FORD:
2007 Mustang

TSB 07-6-7 (Continued)

Figure 1 - Article 07-6-7

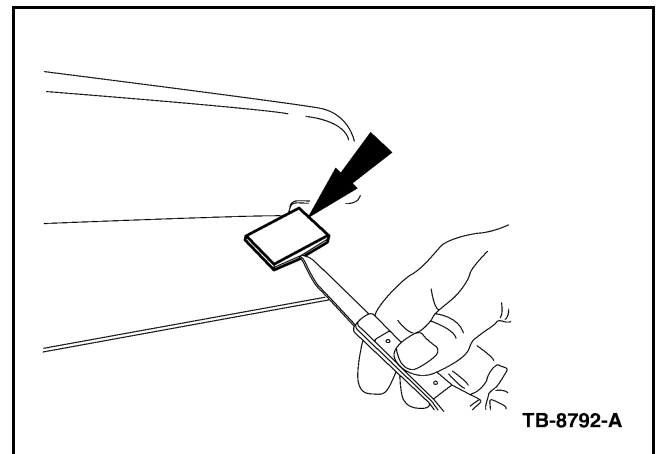
Some 2007 Mustang vehicles equipped with a 4.0L engine may exhibit the spoilers in contact with the deck lid causing paint damage.

1. Cut a piece of Urethane Tape (Hard Foam Part Number 164-R4902) 5/8" X 2" from the Rotunda Squeak And Rattle Kit (Part Number 164-R4900).
2. Remove the backing on the Urethane tape and slide in-between the spoiler and the deck lid on both left and right sides of the deck lid/spoiler. Use a thin, flathead screwdriver or knife to aid in installation. (Figures 1, 2, and 3)
